HORSHAM DISTRICT COUNCIL CONSULTATION

TO:	Horsham District Council – Planning Dept
LOCATION:	Land North of Guildford Road Bucks Green Rudgwick West Sussex
DESCRIPTION:	Outline Planning Application for up to 90 no. residential dwellings (including 40% affordable) all matters to be reserved apart from access.
REFERENCE:	DC/25/1269
RECOMMENDATION:	Modification / More information Holding objection / Modification

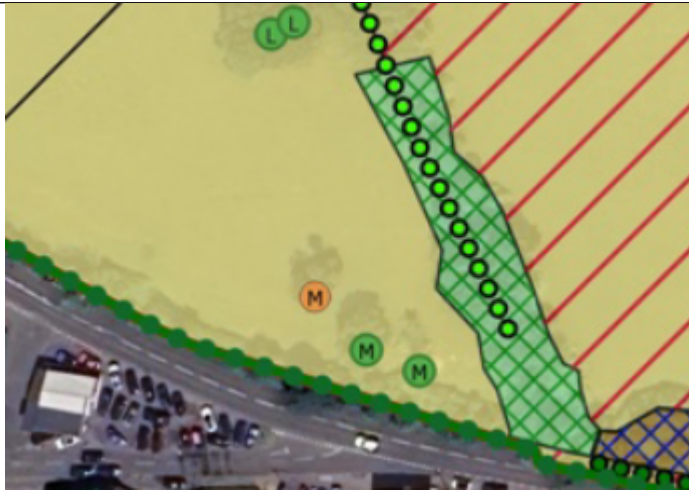
- 2.0 It is noted that other neutral grassland is proposed in both poor and moderate condition on site within the BNG Assessment, with user comments in the metric stating that other neutral grassland in poor condition will be in the 'inner area' and 'flowering lawn', whilst other neutral grassland in moderate condition will be 'areas on perimeter of site' and 'SuDS and swale'. Please can the different condition habitats be distinctively mapped for the purposes of future monitoring. In instances where the grassland will be subject to high levels of disturbance from residential use, it is advised to assign these areas as modified grassland.

Figure 4 in the BNG Report has been amended to map these different condition grasslands. Concern resolved, with thanks.

- ^ Hedgerow lining southern boundary on site, as per Figure 4 in BNG Report.
- v Attenuation create abutting tree RPAs and hedgerow.

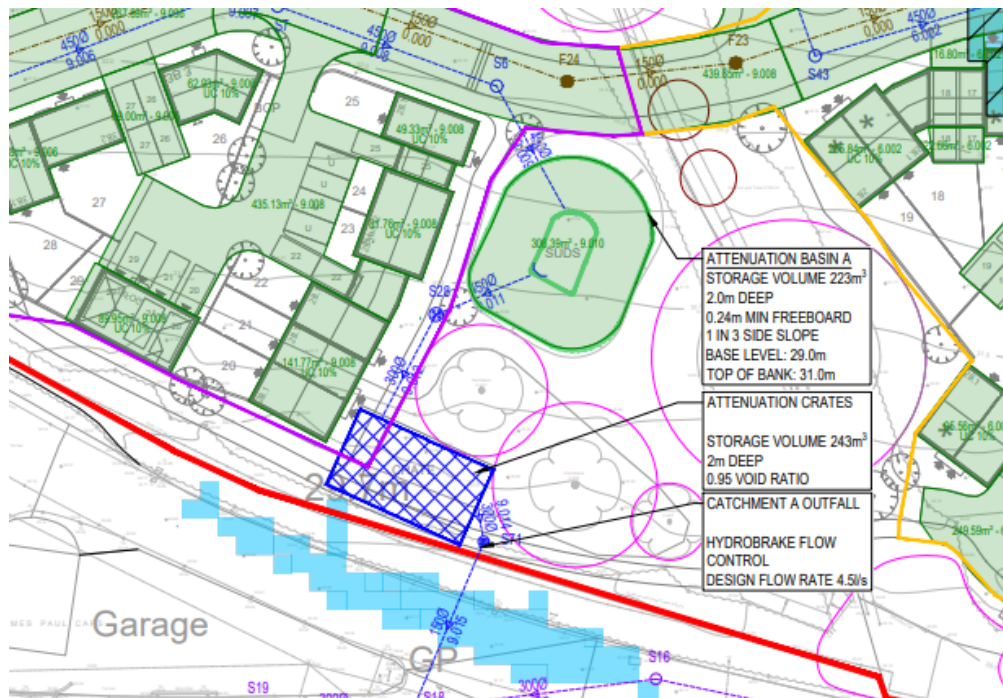
- 2.1 As per the Preliminary Drainage Strategy (Appendix A, Paul Basham Associated Ltd, 2025), an attenuation crate is proposed to be installed in the south of the site and appears to be very close to the retained hedgerow. Please can confirmation be sought as to whether impacts on this hedgerow will be avoided. The ecologist refers to attenuation basins, however the original comment refers to the attenuation crate – I have copied two extracts below to illustrate this point. Having discussed with the HDC Arboricultural Officer, it is our view that the installation of the attenuation crate is not possible without hedgerow removal and encroaching on tree root barriers adjacent to the existing tree RPAs. Therefore, this will need amending – it is recommended to relocate the attenuation crates or remove the 2-3 plots to the west of the proposed crate to provide sufficient space for installation. A minimum 1.5m distance is required for installing underground crates near hedgerows. Any forecast hedgerow removal will need to be accounted for within the metric.
